From: WILLIFORD Dennis (AREVA) [Dennis.Williford@areva.com]
Sent: Friday, November 18, 2011 9:22 AM
To: Tesfaye, Getachew
Cc: BENNETT Kathy (AREVA); DELANO Karen (AREVA); ROMINE Judy (AREVA); RYAN Tom (AREVA); GUCWA Len (EXTERNAL AREVA)
Subject: Response to U.S. EPR Design Certification Application RAI No. 490 (5788), FSAR Ch. 6, Supplement 3
Attachments: RAI 490 Supplement 3 Response US EPR DC.pdf

Request for Additional Information No. 490, Supplement 3

U. S. EPR Standard Design Certification

SRP Section: 06.02.02 - Containment Heat Removal Systems

Figure 06.02.02-100-1—Calcium Carbonate Solubility IRWST Chemistry Conditions

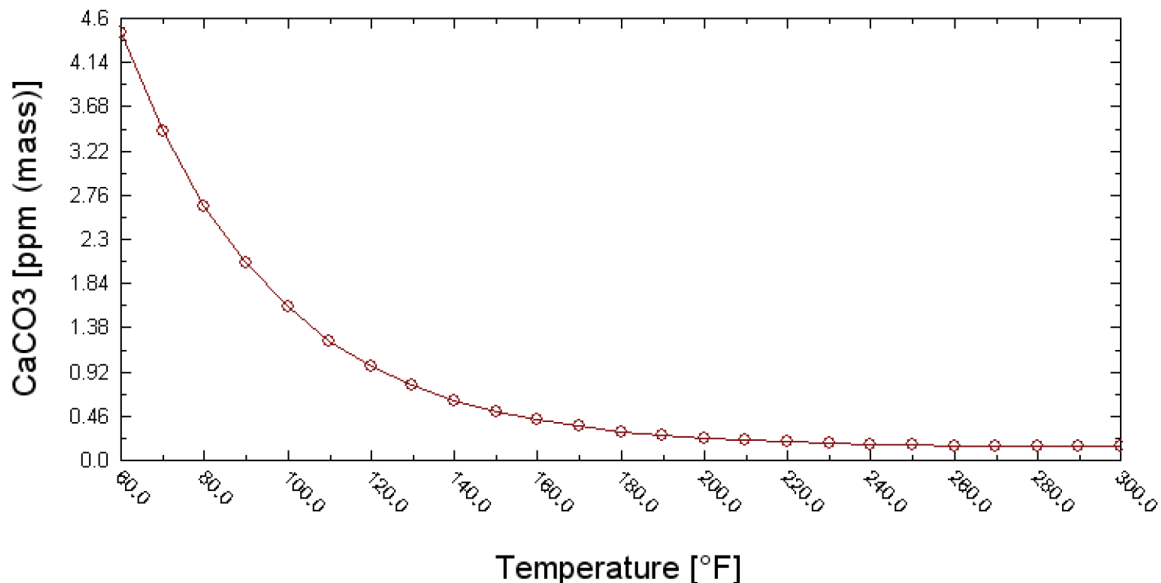
The staff requests that AREVA modify Appendix D of ANP-10293P to address directly and completely the change in IRWST peak temperature from 230°F to 250°F. For example, there is a statement on page D-5 that, "The temperature during the test was controlled to simulate the IRWST response to a large-break LOCA as closely as practicable." The autoclave testing was conducted at a lower temperature than the IRWST peak, and this needs to be acknowledged and justified. Another example is on page D-11, which has a statement about Nukon binder stability relative to 230°F (rather than 250°F).

The autoclave test was conducted using the temperature profile available at the time of the test, which had a peak temperature of 230°F. A very short exposure time at 250°F is not expected to affect binder stability as the NUKON material safety data sheet (MSDS) notes that the phenolic resin begins to decompose at a temperature of ≈400°F.

Thermodynamic modeling using OLI Analyzer™ shows that the solubility of CaCO₃ and SiO₂ do not change significantly or irregularly between 230°F and 250°F, as shown in Figures 06.02.02-100-1 and 06.02.02-100-2. Therefore, the material release equations developed from literature data and the autoclave testing may be extrapolated between 230°F and 250°F with reasonable certainty because:

- The solubility of the pertinent species, CaCO₃ and SiO₂, does not change significantly over the temperature range in question.
- In the absence of a significant solubility change, dissolution/corrosion kinetics are regular and predictable, allowing reasonable extrapolation.

Figure 06.02.02-101-1—Calcium Data Fit – Linear

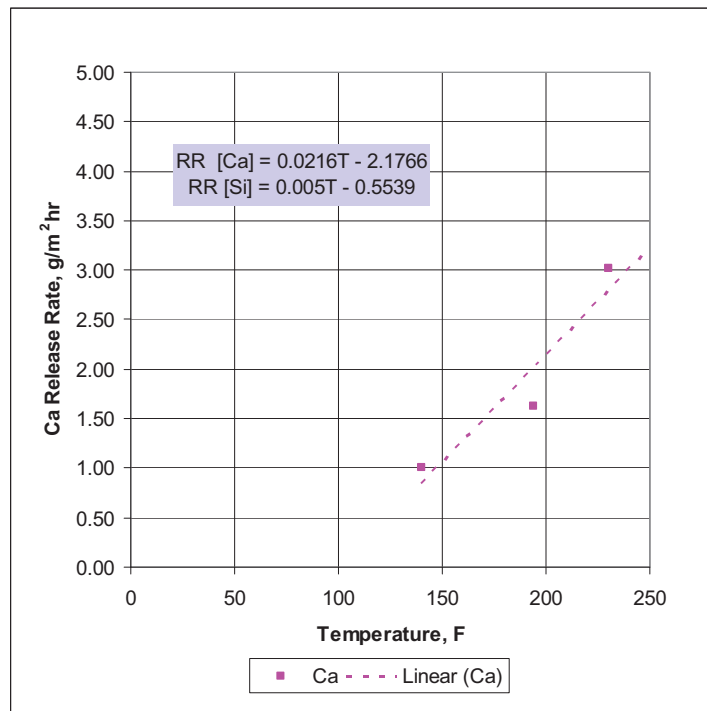
The staff requests that AREVA either justify the linear extrapolation of the calcium release rate shown in Figure D.3-1 or propose an alternative. It does not appear to the staff that the linear extrapolation from 230°F to 250°F is justified and conservative. Rather, it appears that an exponential form would fit the data better and at 250°F would predict a significantly higher release rate than the proposed linear extrapolation.

In order to justify the linear fit of the calcium data shown in Figure D.3-1 of ANP-10293P, AREVA NP evaluated linear, polynomial, and exponential fits of the data points, as shown in Figure 06.02.02-101-1 through Figure 06.02.02-101-3. Each of the calcium release rate equations determined from the Excel data fits was applied to the newest IRWST temperature profile to calculate the total quantity of concrete released from the heavy floor as a function of time. As shown in Figure 06.02.02-101-4, the linear data fit produced the largest calcium release prediction, since it more encompasses the middle of the temperature range where the bulk of the transient time is spent. Note that since this is a graph of cumulative releases, the slope of the curves correspond to release rates, which change with time because of changes in the IRWST temperature.

Because the linear data fit produced the highest predicted calcium releases, it was deemed to be conservative and was used in the chemical debris generation calculation summarized in Appendix D of ANP-10293P.
